#### ADDENDUM NO. 1

PROJECT: S&C # P160218; Stoddard County Road 488 Bridge

#### **SUBJECT: Project Manual Changes/Clarifications**

#### **SUBJECT: Project Plans Changes/Clarifications**

SHEET: **4.1**

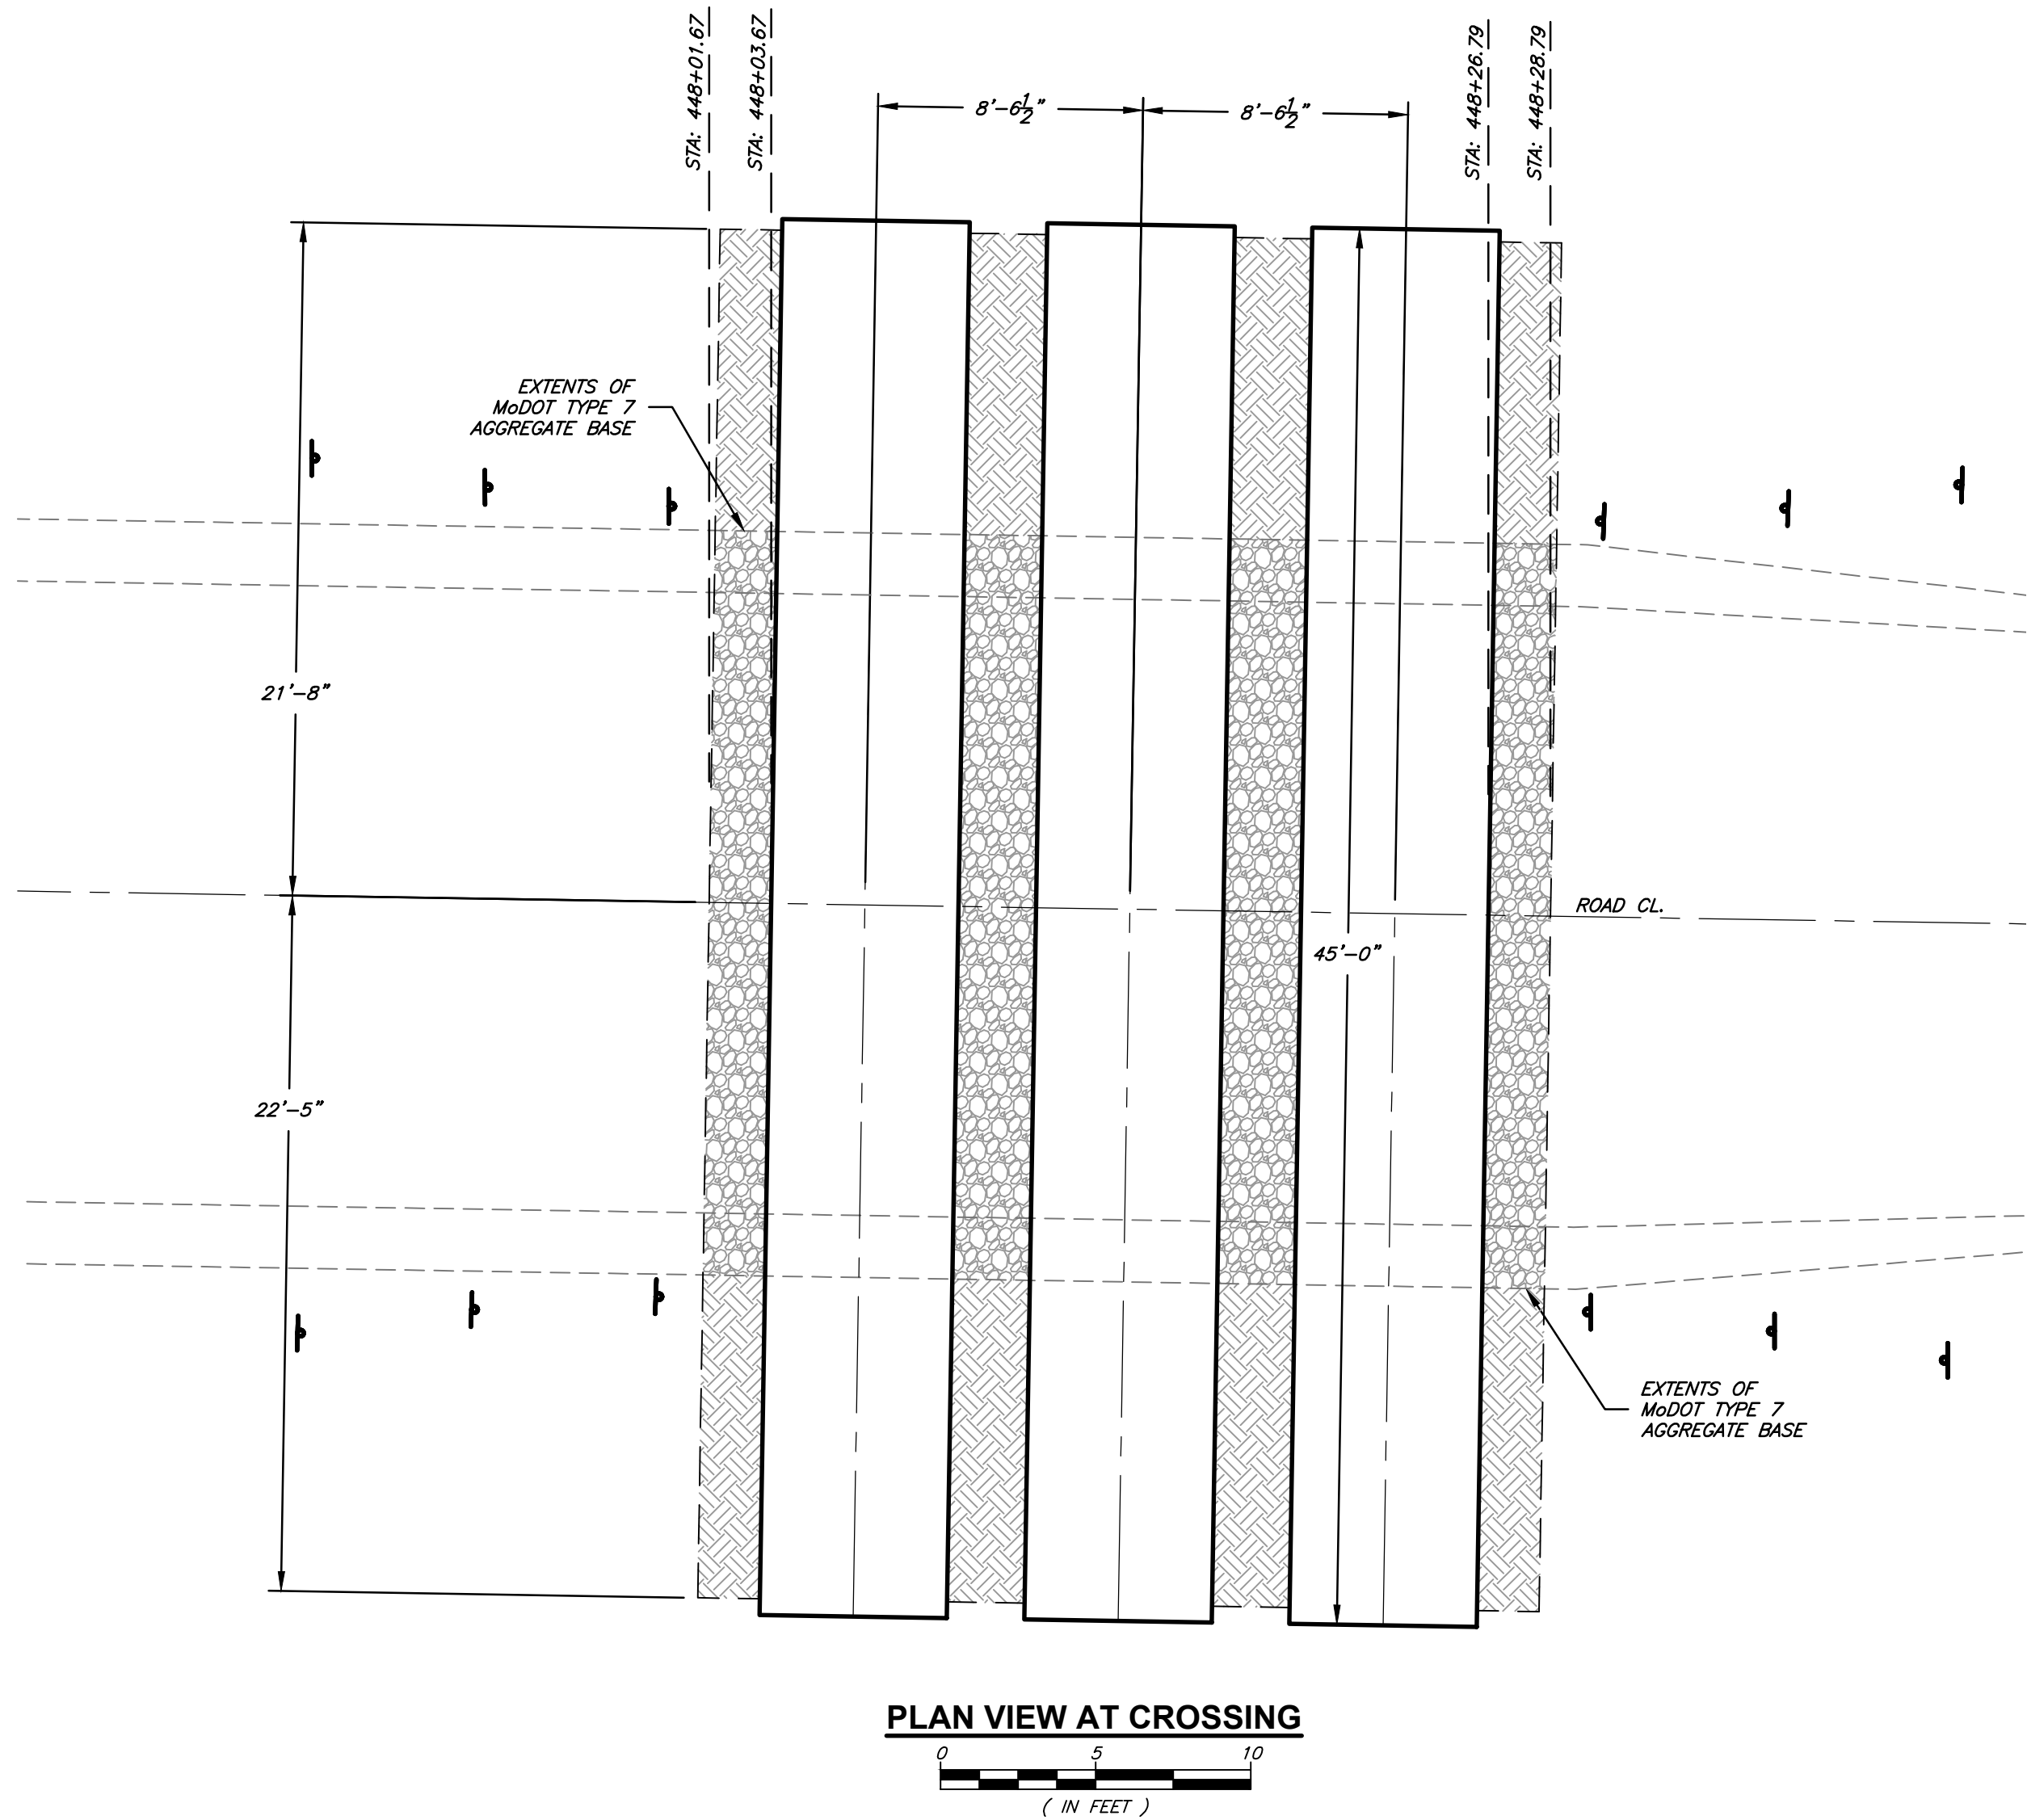
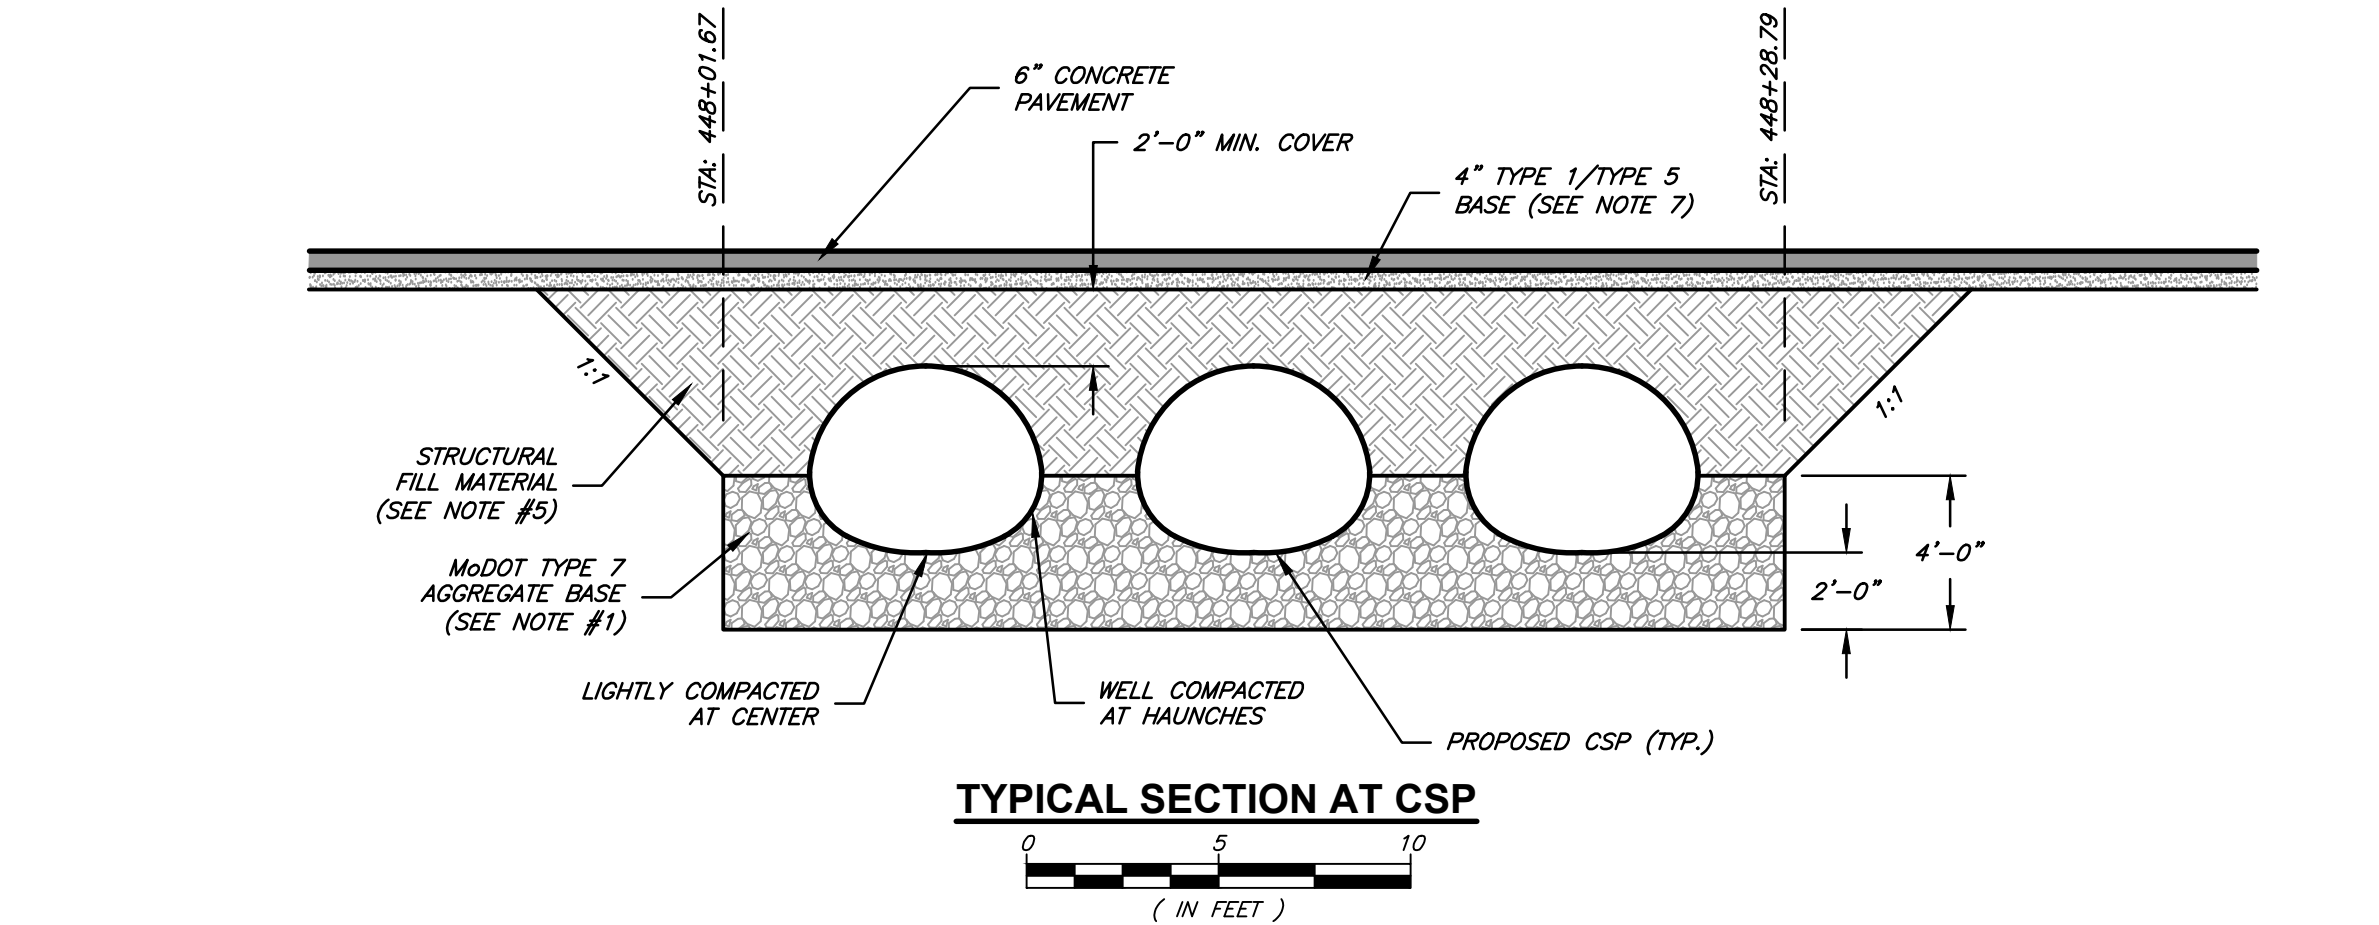
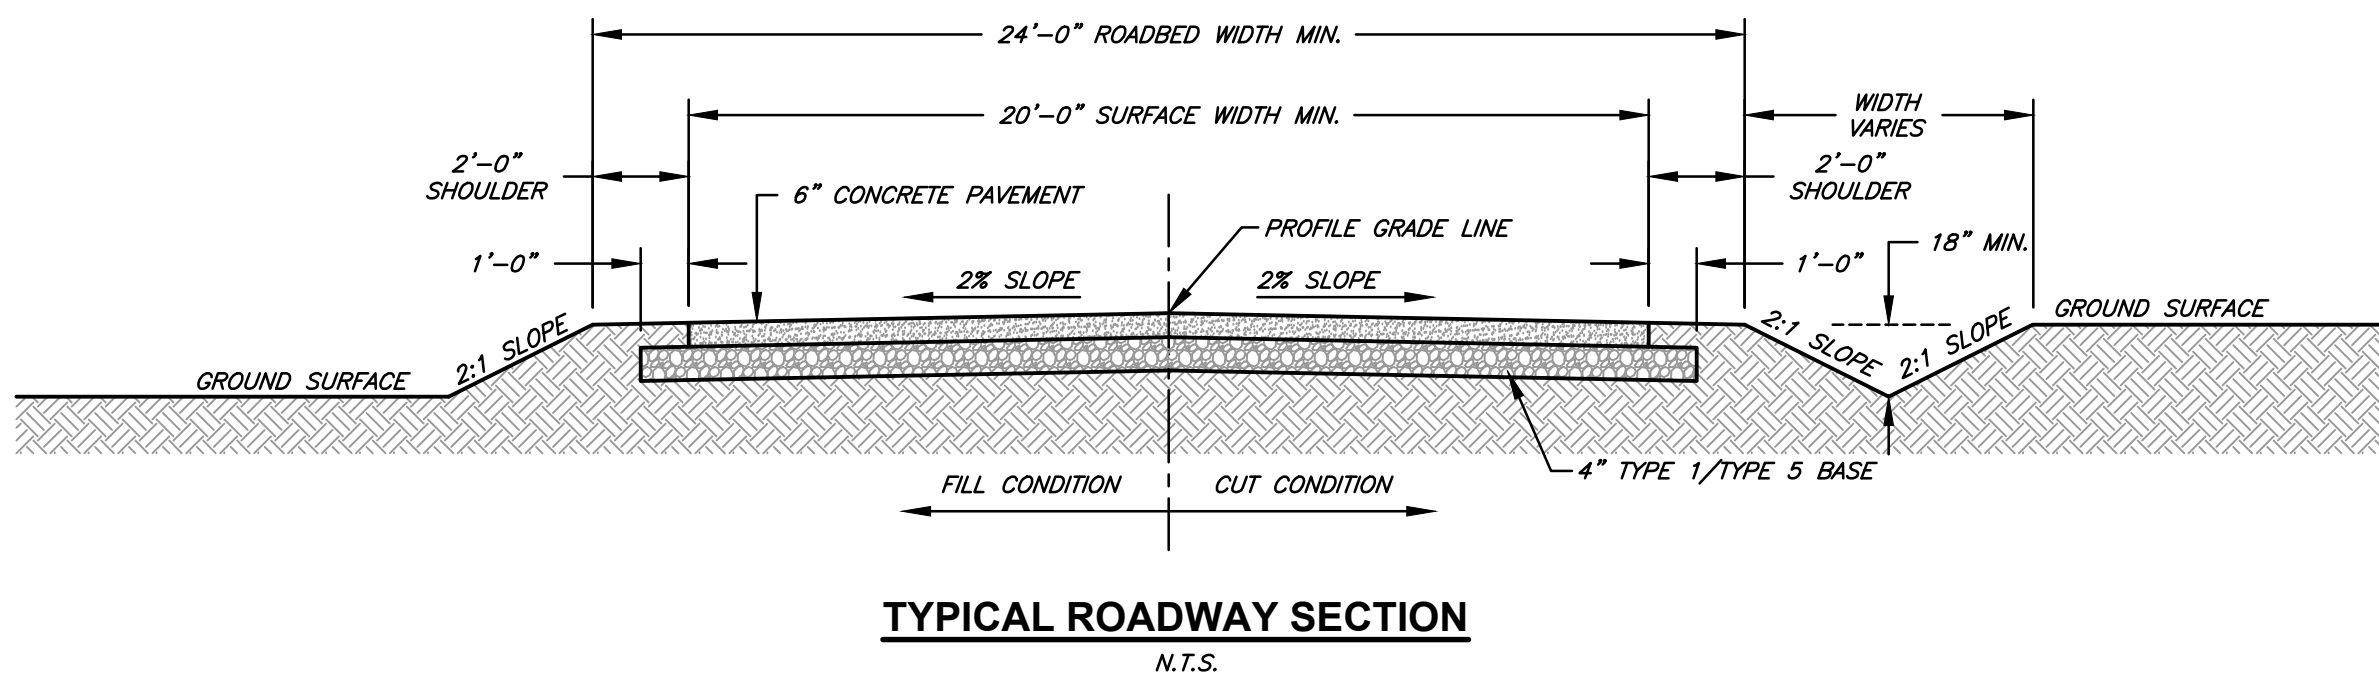
1. Sheet 4 – ARCH PIPE DETAILS AND LAYOUT
  - An additional detail was provided for the road details regarding the alternate paving. See attached sheet 4 and 4.1 for clarification.
